MFN 06-284

Subject: **Response to NRC Request for Additional Information Letter No. 18  
Related to ESBWR Design Certification Application - Containment  
Design - RAI Numbers 6.2-11, 6.2-21, 6.2-26 and 6.2-27**

**Response to NRC Request for  
Additional Information Letter No. 18  
Related to ESBWR Design Certification Application  
Containment Design  
RAI Numbers 6.2-11, 6.2-21, 6.2-26 and 6.2-27**

Figure 6.2-11.1 Drywell Pressure Responses of 4 LOCA Types

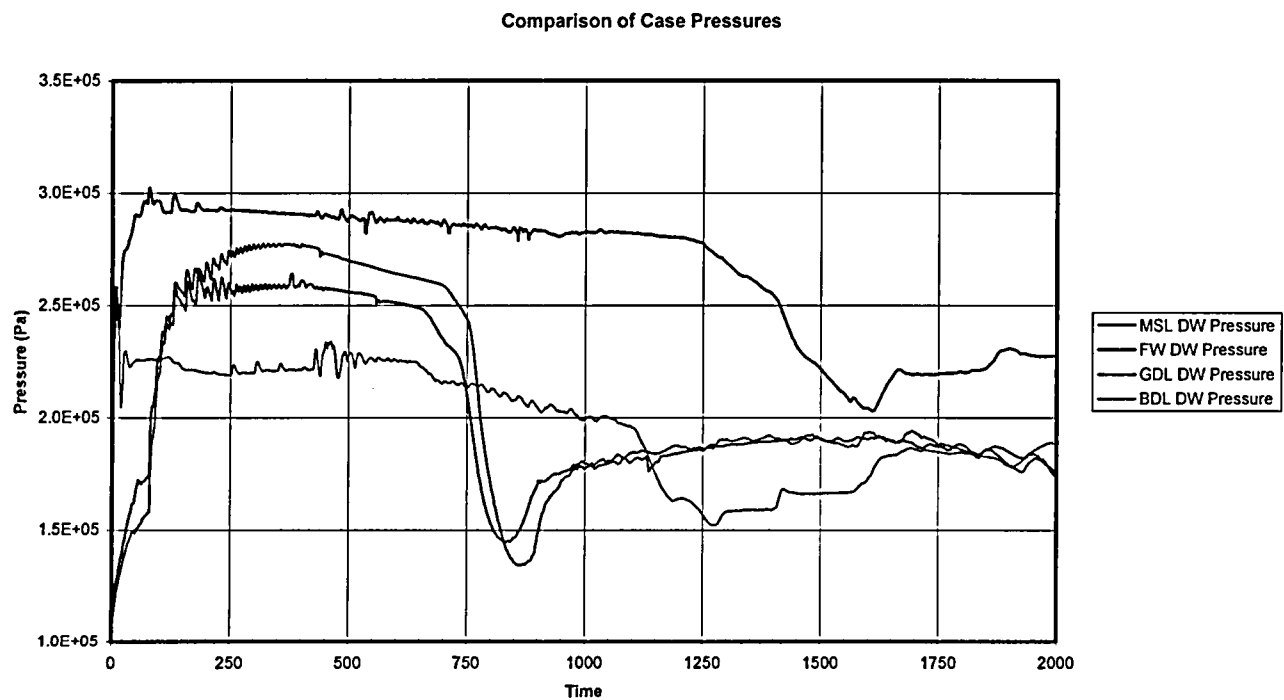
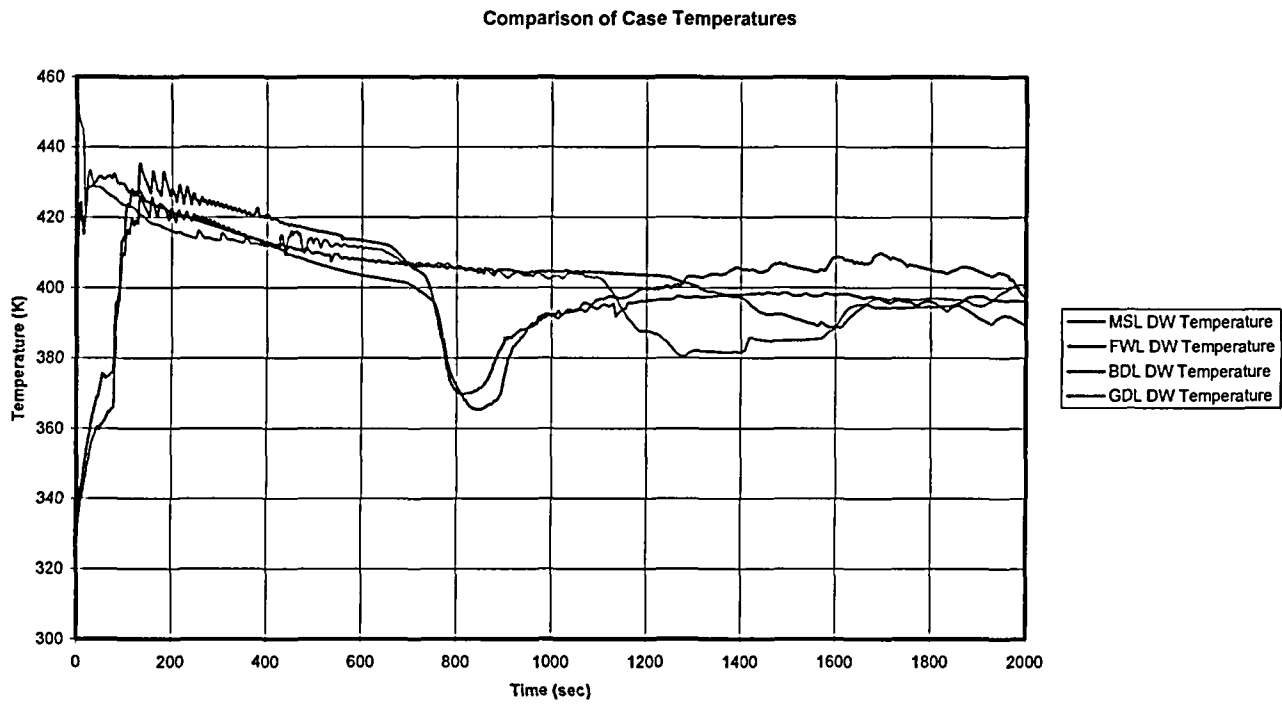
NRC RAI 6.2-11

*Provide the results of the evaluation(s) and compare to the design value(s). The DCD Section 6.2.1.1.4 indicates that the MSLB will not result in unacceptable results but it does not indicate if other LOCAs were evaluated to conclude this is the limiting case. Provide a discussion on how the limiting cases were identified, for both the drywell and wetwell. Address drywell results and, as appropriate, wetwell results.*

Among four design base LOCA break types analyzed for DCD, Feedwater Line (FWL) break results in the highest peak drywell (DW) pressure and Main Steam Line (MSL) break results in the lowest peak DW pressure. The peak pressure of GDCS Injection Line (GDL) or Bottom Drain Line (BDL) break falls between those of FWL and MSL breaks, as shown in Figure 6.2-11.1. DW temperatures are comparable for these 4 types of breaks, except that FWL and MSL cases have higher temperature between 800 and 1100 seconds, as shown in Figure 6.2-11.2. It is therefore adequate to analyze FWL and MSL break scenarios to provide diverse DW environmental conditions which envelope other break locations, for determining the minimum DW pressure and the pressure differential between WW and DW as consequence of inadvertent initiation of drywell spray. The results are tabulated below. An inadvertent drywell spray initiation during a MSLB resulted in a lower DW pressure. An inadvertent drywell spray initiation during a FWLB resulted in a higher WW to DW pressure differentials. The results are all within the design capability. An inadvertent drywell spray initiation during a normal operation was also analyzed and the results were inconsequential.

Results of three analyzed cases are summarized below:

FWL Break	MSL Break	No Break
Drywell Spray Flow Rate (GPM)	2000	1000	2000
Spray initiation Time (sec. after break)	1300	1000	0
Minimum Drywell Pressure (psia)	25.3	17.5	14.9
Maximum Wetwell to Drywell $\Delta P$ (psid)	2.88	1.40	0.000028
Design Wetwell to Drywell $\Delta P$ (psid)	3.0	3.0	3.0

The second sentence of the last paragraph of DCD Section 6.2.1.1.4 will be revised to read:

“The Feed Water Line (FWL) and Main Steam Line (MSL) break scenarios provide diverse Drywell environmental conditions which envelope the other break locations. The results of the FWL and MSL break analyses show that the containment does not reach a negative pressure relative to the reactor building, and the maximum Wetwell-Drywell differential pressures are within the design capability.”
